Re: Florence Copper Project
Draft Underground Injection Control Permit R9UIC-AZ3-FY11-1

Southwest Value Partners
Comments on
Draft Underground Injection Control Permit R9UIC-
AZ3-FY11-1
Issued to Florence Copper, Inc. for the Florence
Copper Project
Florence, Arizona

Figure 1. Region 9 Exemption Guidance

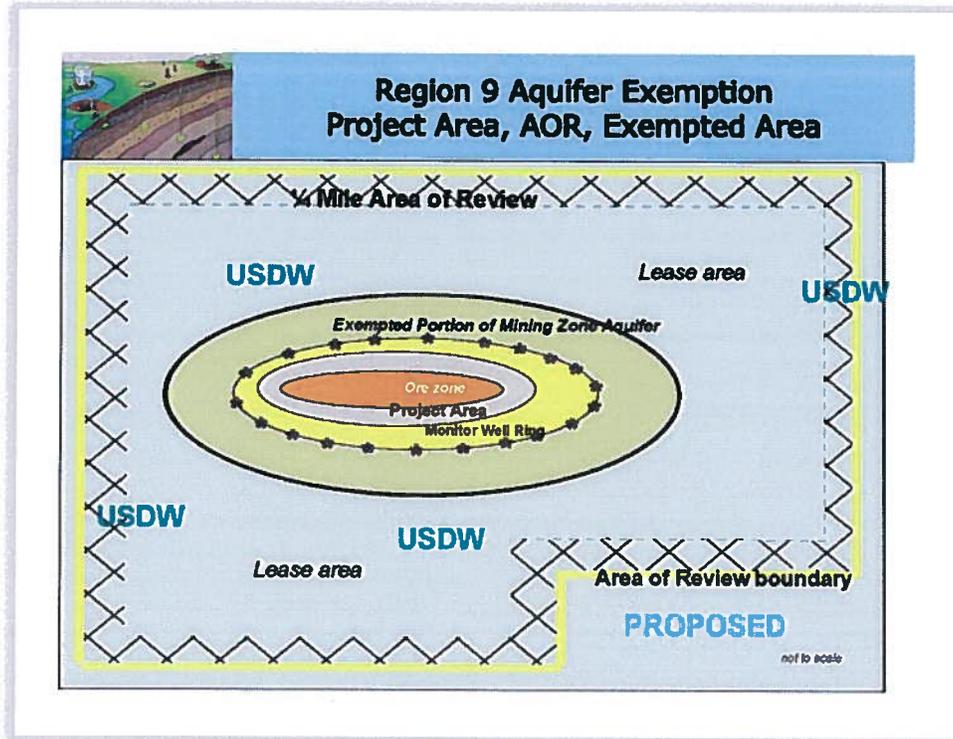
Beyond the regulations, EPA Region 9 has published guidance that requires the agency to take all aquifer exemptions very seriously. In particular, when addressing a proposed mining permit, the exempted area is to be kept *as small as possible* while still allowing mineral extraction. Appendix F provides specific references to recent EPA rule-making and permitting decisions that implement this policy. It also cites the source of the figure below. This Region 9 product that has recently been used to show an exemption is appropriate only inside the Area of Review, and not far outside the ring of monitoring wells.

The Statement of Basis for the Draft Permit claims to justify a large exemption area because there are no drinking water wells inside of it today, and existing downgradient drinking water wells are too far from the PTF to be impacted. As a matter of law, this justification is completely wrong; EPA regularly acts to protect aquifers, not just existing wells. We challenge EPA to find any legal authority for its position, or explain why it should ignore its own guidance, illustrated in Figure 1 above.

Figure A-2: Sulfate Values in Observation Wells During BHP Pilot Test³¹

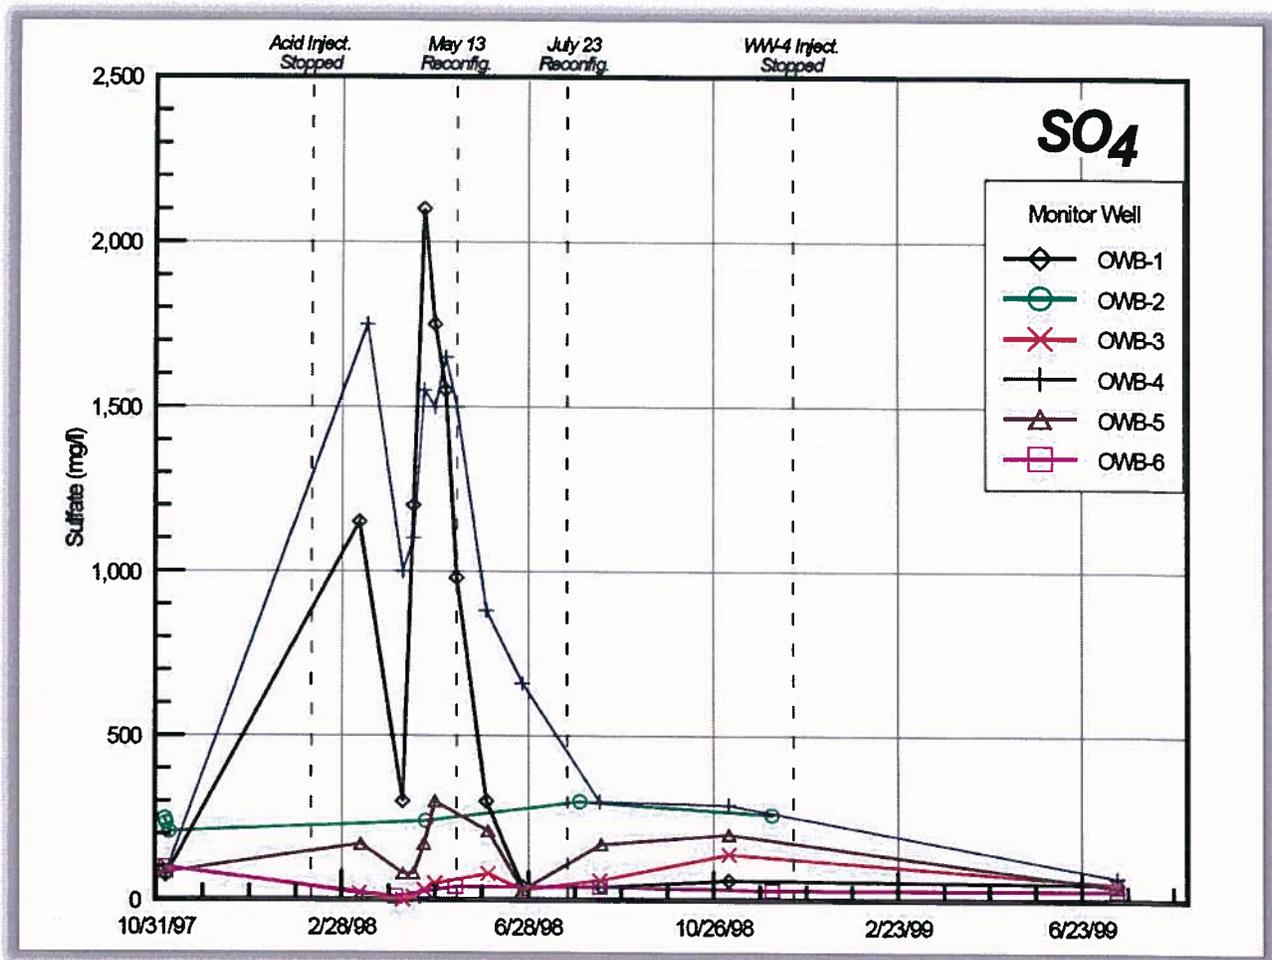
Neither EPA nor ADEQ required BHP to monitor for sulfate, pH, or any other water quality parameters at the observation wells. But BHP collected sulfate data from those wells during the rinsing phase of the project for its own purposes. Four wells experienced steady and comparatively low sulfate levels of a few hundred mg/l, indicating that no acid reached the wells. But both OWB-1 on the northeast corner and OWB-4 on the southwest corner of the well field experienced numerous high sulfate concentrations in March and April 1998, during groundwater restoration. In fact, in one sample sulfate exceeded 2,000 mg/l, a value that is ten times background and even higher than the sulfate at the recovery well inside the well field.

According to Dr. Wilson, the only explanation for these sulfate concentrations is that injected acid solution migrated horizontally to reach the observation wells. And this conclusion is confirmed by the pH data for these same wells, an analysis of which shows results consistent with an escape of acid solution. Review of these results would lead one to believe that injected acid solutions had also migrated beyond the observation wells completely undetected even though all permit conditions were being met.

Figure A-3: Conductivity Difference from Background in mS/m After One Month of Acid Injection During BHP Pilot Test³⁷

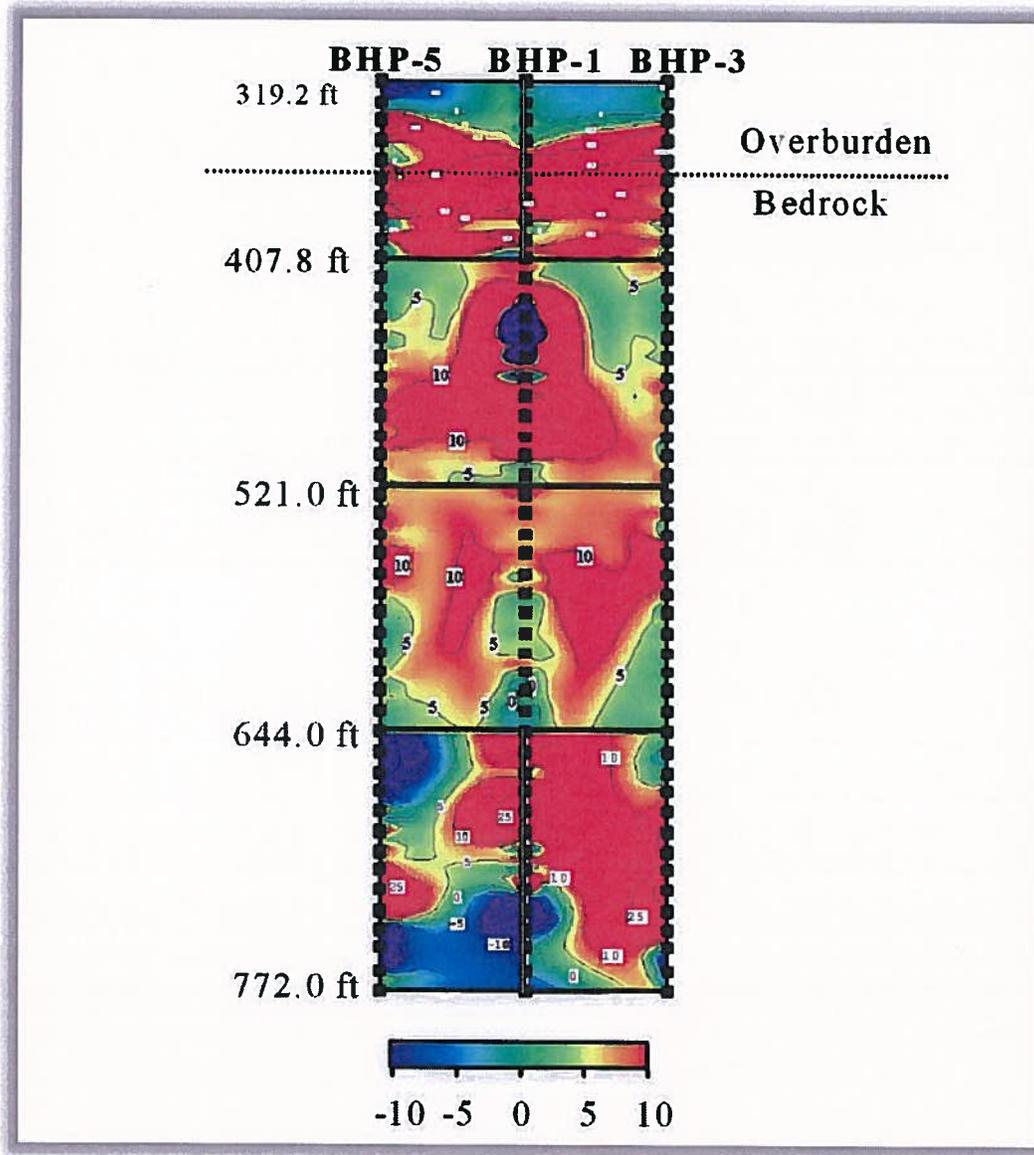
Injected acid also moved vertically into the LBFU during the BHP Pilot Test. BHP installed electrodes along the wellbore of the five injection wells at three-meter intervals. Changes in electrical resistance were measured before and after injection. Because the injected fluid had smaller resistance than formation water, zones with negative changes in resistance represented the flow paths of injected solution.³² These flow paths are depicted in red in Figure A-3 below, with “overburden” representing the LBFU.

These measurements show that BHP’s acid solution migrated vertically 20 feet into the LBFU. This was predicted by BHP³³ and allowed by BHP permit. And this figure is based on acid migration after only 30 days of injection. Region 9 should anticipate greater impacts to the LBFU from the FCI’s more than 400-day PTF. The damage will be even worse from a commercial project where multiple mine blocks will inject millions of gallons of acid over many years.

Figure A-5: Recommended Location of Additional Observation Wells

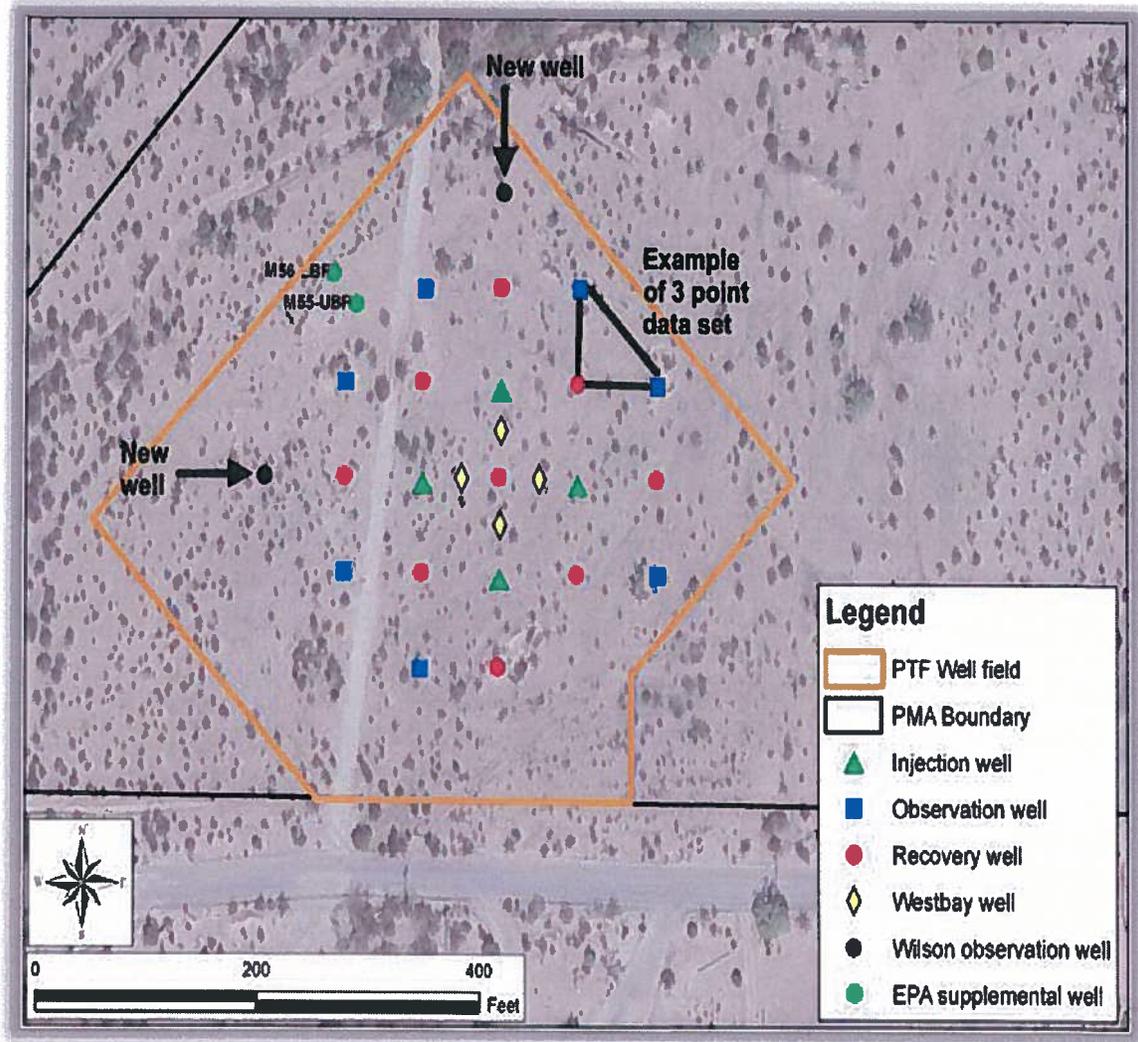
flows in these directions. Consideration of the BHP Pilot Test results mandates that two additional observation wells be installed as depicted by Dr. Wilson in Figure A-5.

Figure B-1

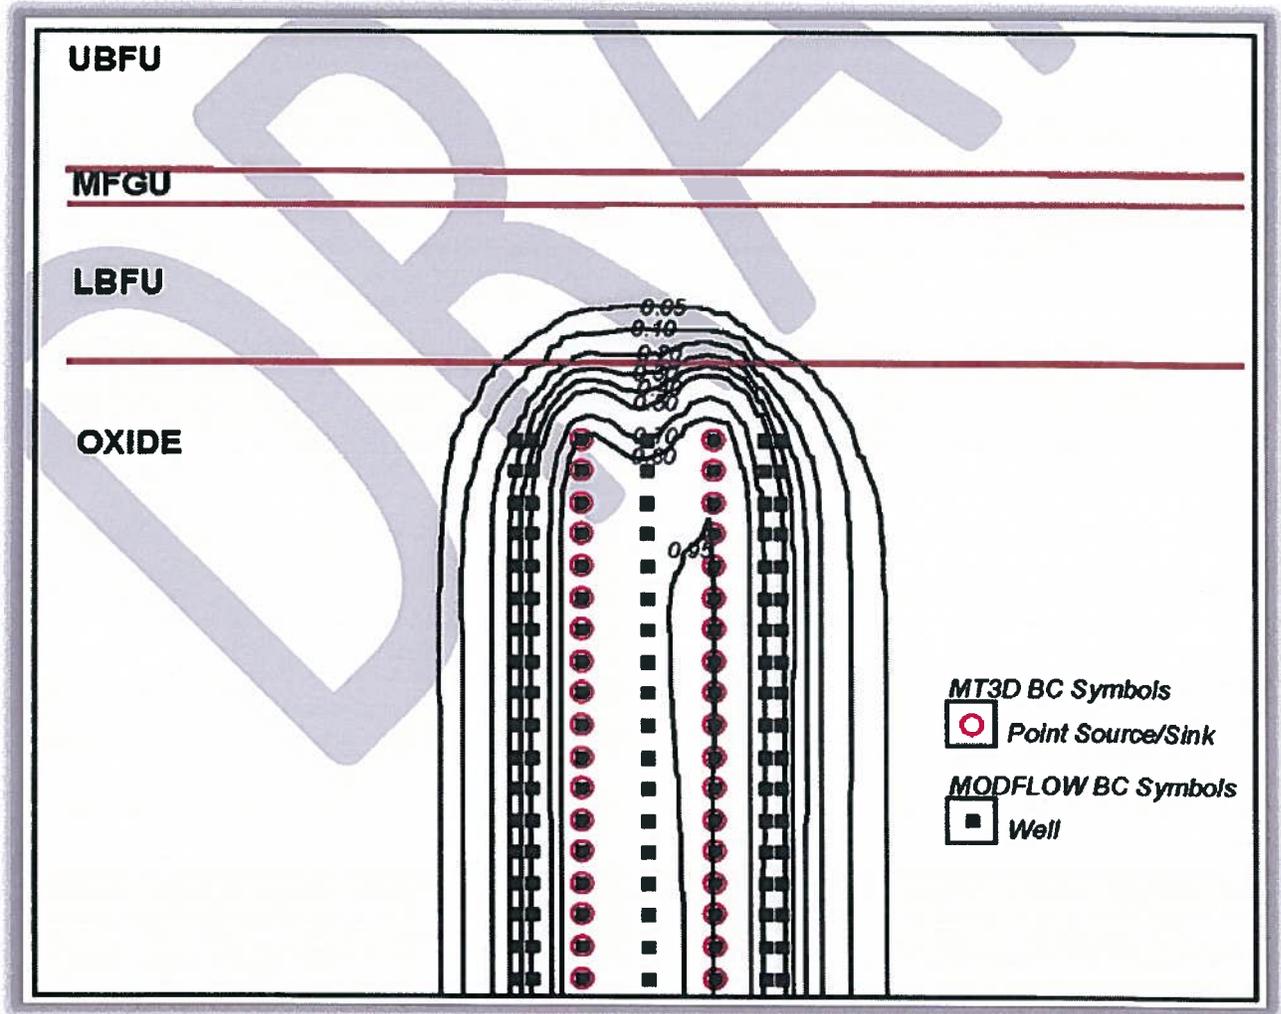
Figure 23 presents a vertical concentration profile from a cross section between injection wells BHP-6 and BHP-8, and production wells BHP-1, BHP-10, and BHP-12. The wells are placed 40 ft underneath the LBFU and oxide contact zone. The cross section between the two other injection wells has similar concentration contours. It is seen that the injected solution had moved 20 ft to 40 ft into the LBFU at the end of one year. The simulations assume that the hydraulic conductivity in the LBFU does not change. The laboratory test on cores from LBFU showed that the permeability of LBFU

could be reduced 50% during the leaching because of mineral precipitation. The actual vertical excursion could be smaller.⁵⁹

Figure C-1. Hydraulic Conductivity Zones Within the Oxide Bedrock in the 5-Spot⁶⁶

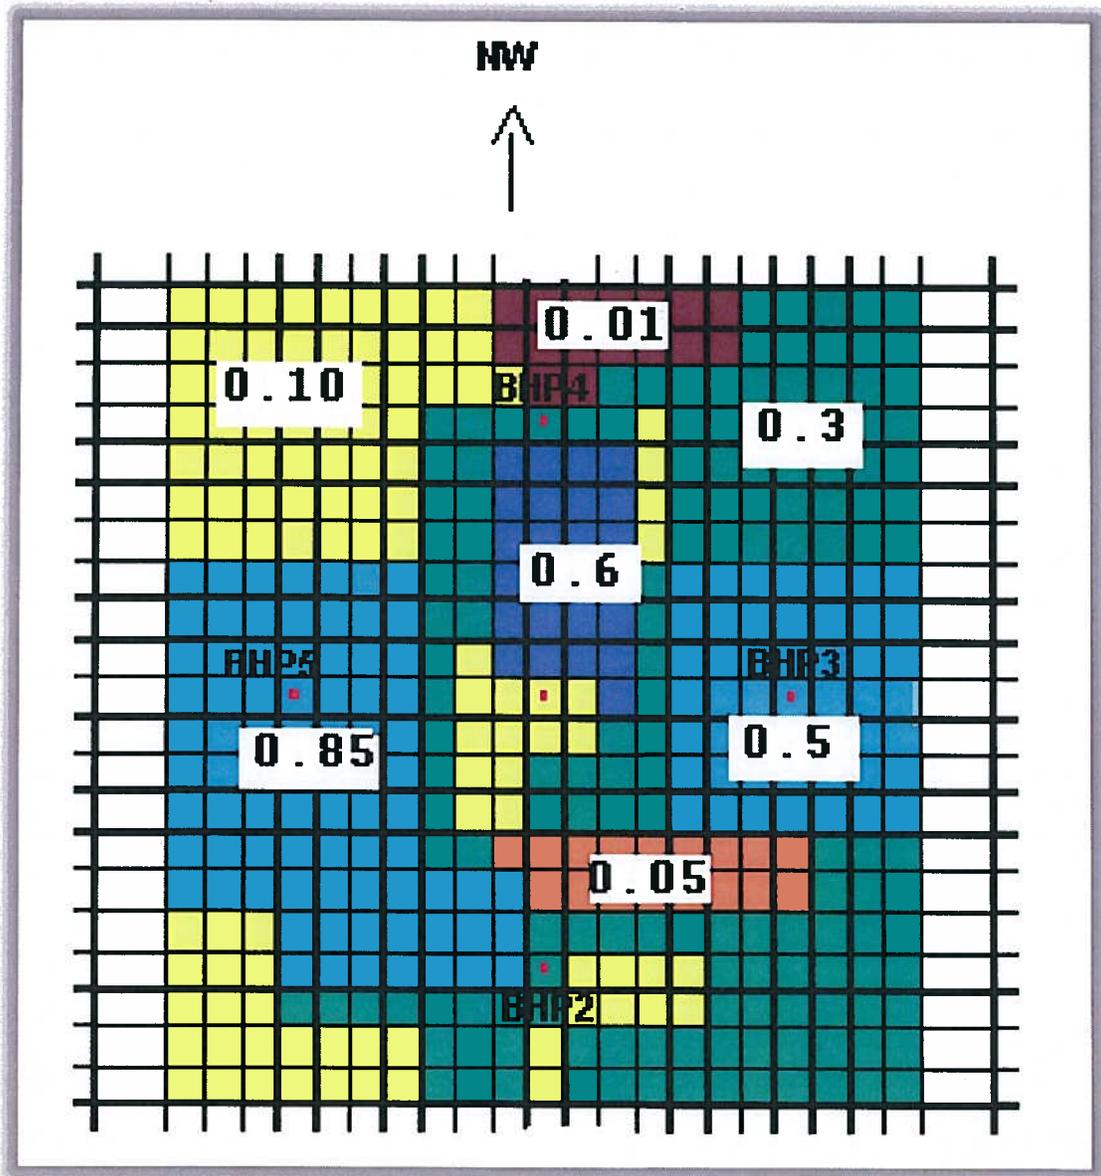
As depicted in Figure C-1, SRK developed a map of hydraulic conductivity values obtained through BHP's aquifer testing program, which was relatively comprehensive. There is no indication at all of the homogeneity that FCI's flow model assumes. The map indicates that some parts of the ore body are 100 times as permeable as others. Values are as high as nearly a foot per day, which would allow good flow and provide a pathway for solute transport. The lowest is one-hundredth foot per day (tenth of an inch per day), which won't allow good flow. If a monitoring well were placed in areas of such low conductivity, they would be useless in detecting an acid escape.

Figure C-2. Calibrated Results of Hydraulic Conductivity.⁶⁷

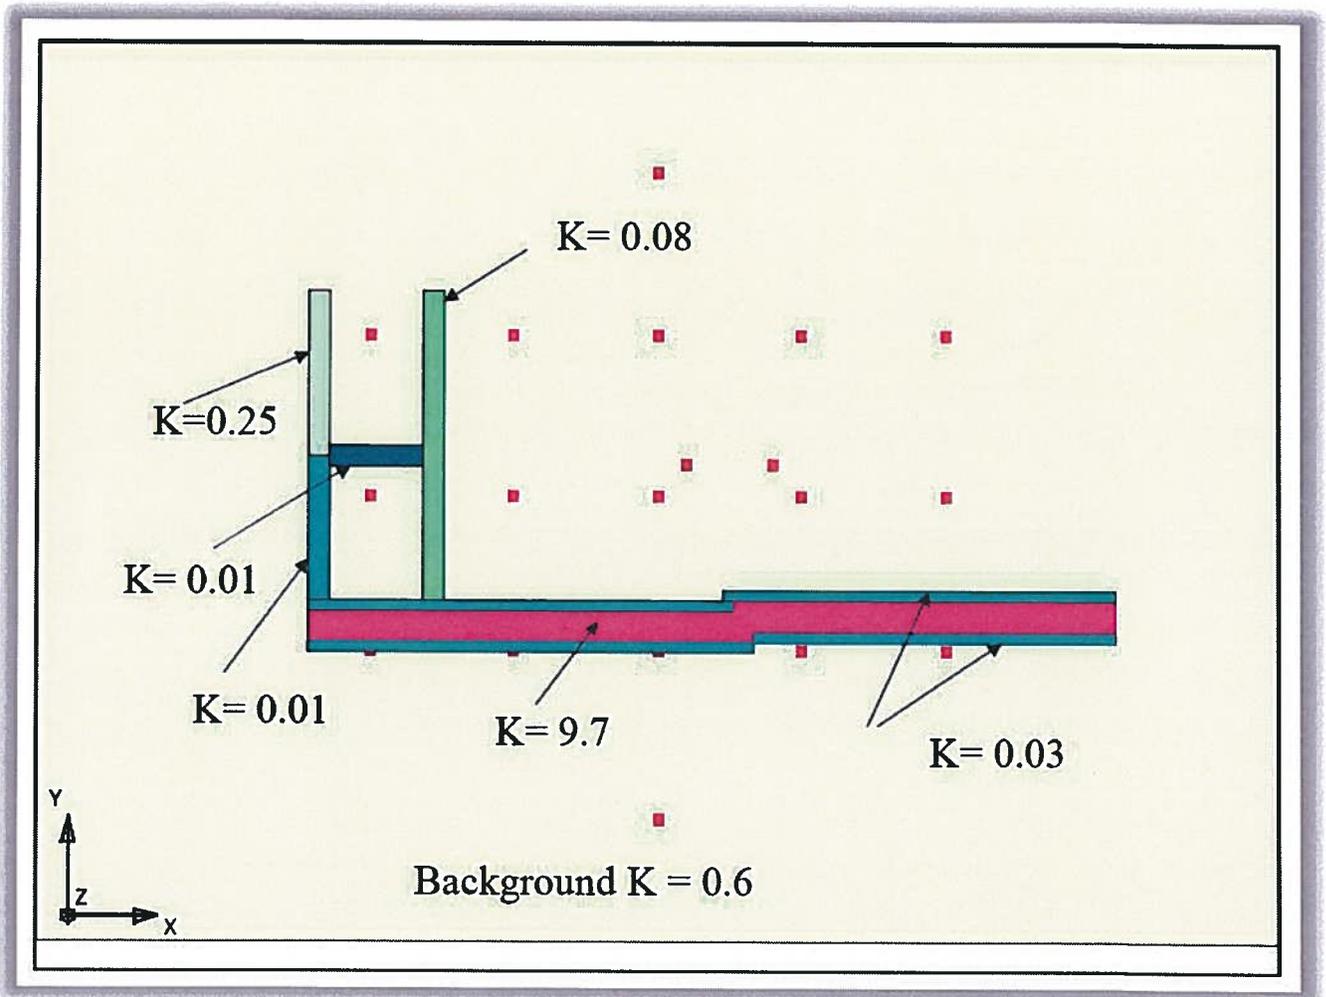
BHP prepared a map of hydraulic conductivity based on tracer tests done before and after the project, provided in Figure C-2. The red bar at the bottom is a short-circuit—a preferential flow pathway for water to move in an east-west direction near the bottom of the project site. When site geology has short-circuits, acid escapes are possible even when water balance and gradients seem demonstrate hydraulic control.

Figure C-3. Injection and Recovery Flow Rates – BHP Test.⁶⁸

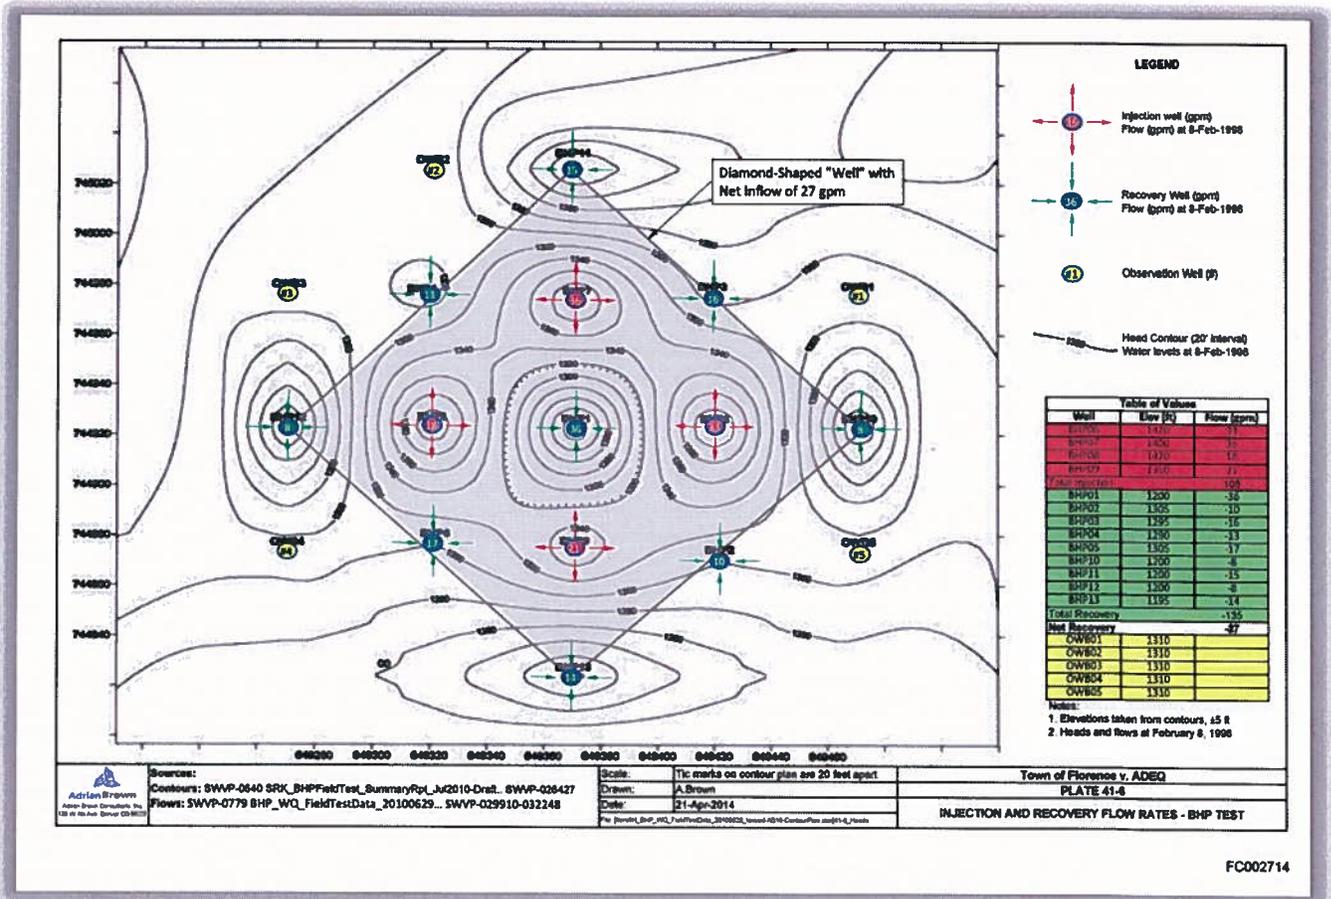
Finally there is a water table map prepared by FCI's expert, provided in Figure C-3, showing large cones of impression at injection sites, and cones of depression around recovery wells. Well pumping rates were similar among wells, but notice how much smaller the upward cone is on the south side of the area—the area where the tracer tests found a short-circuit. This is an example of a real-world project impact that would never even be hinted at by a model of the type that FCI has prepared and EPA has accepted.
